From: "TURKETT, JAMES W JR" <JTURKETT@scana.com>
To: "Robert Martin" <REM@nrc.gov>
Date: 9/7/05 11:00AM
Subject: FW: Answers to RAI

Enclosure 2

Response to RAI
V.C. Summer Tube Inspection Report

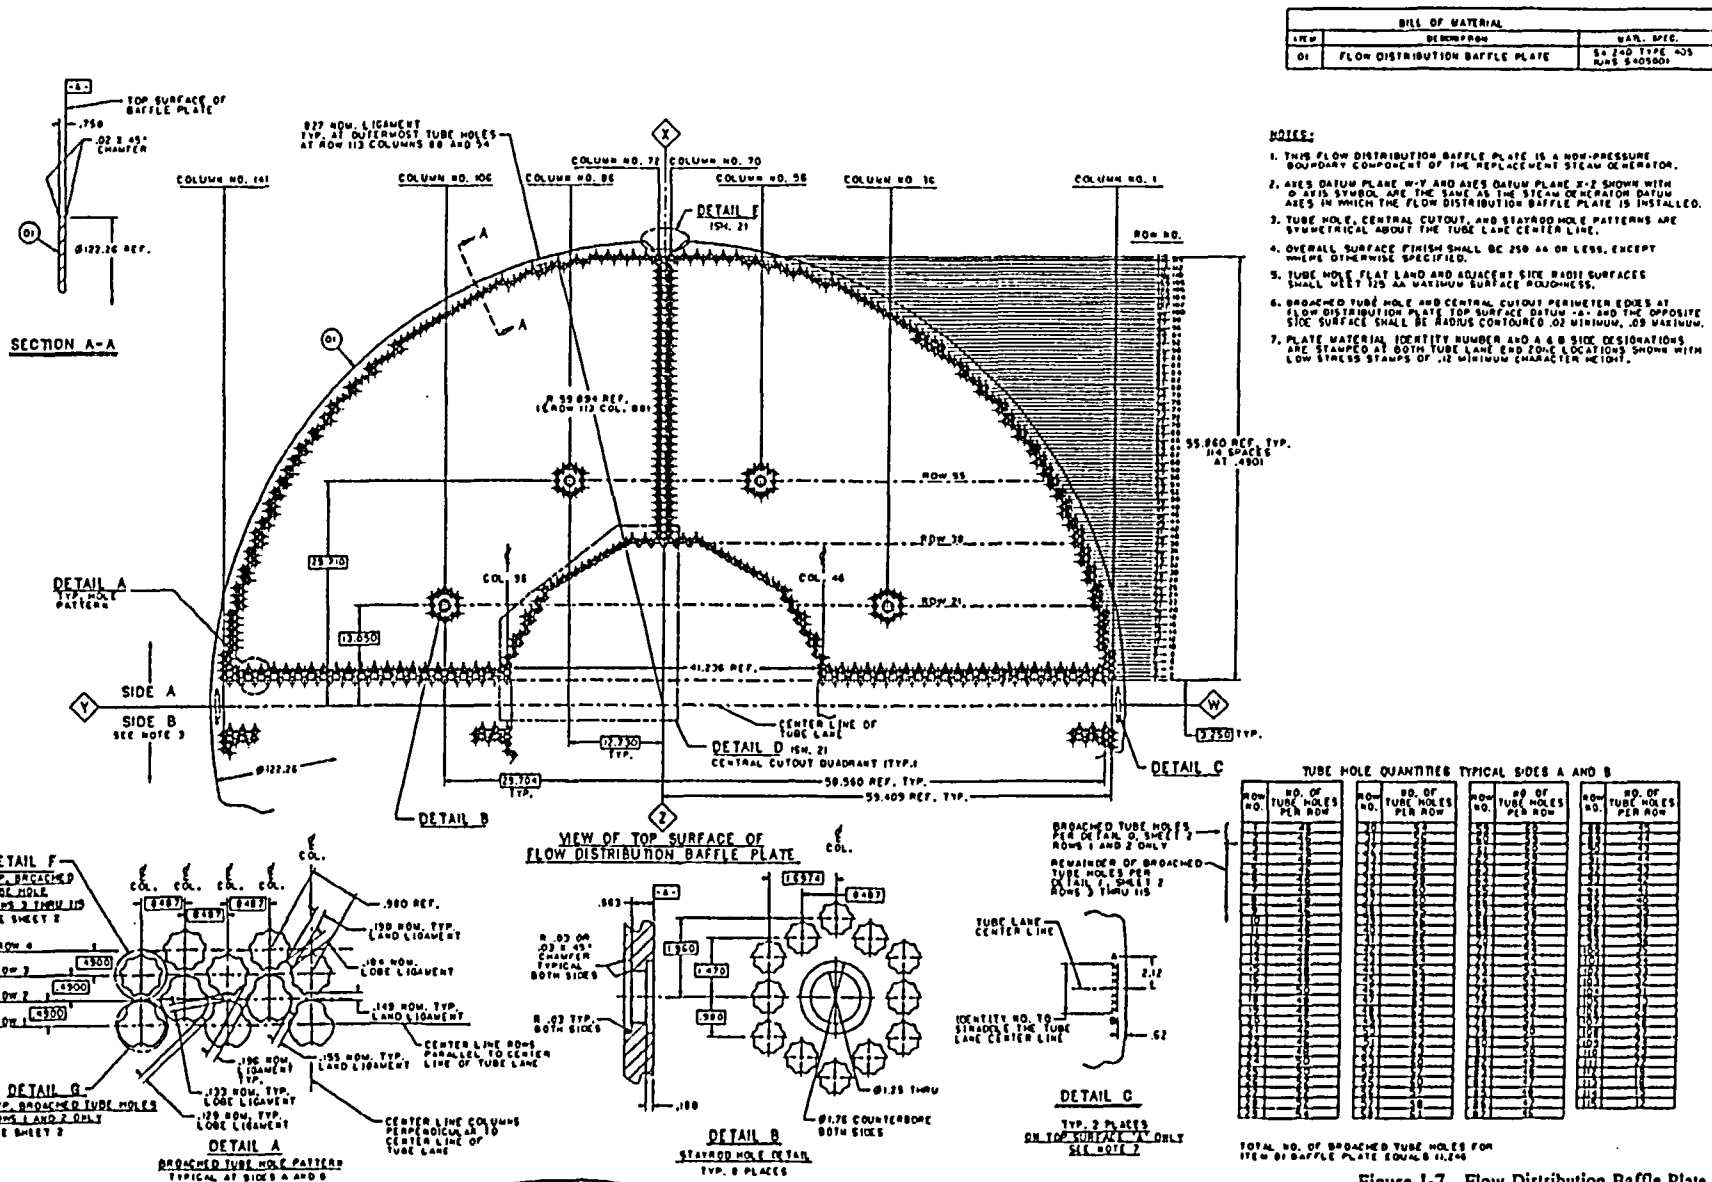
The penetration of the AVB's are

Set 1 Penetrate to Row 1 (some only reach Row 9)

Set 2 Penetrate to Row 19 (some only reach Row 23)

Set 3 Penetrate to Row 43 (some only reach Row 47)

Set 4 Penetrate to Row 75 (some only reach Row 79)
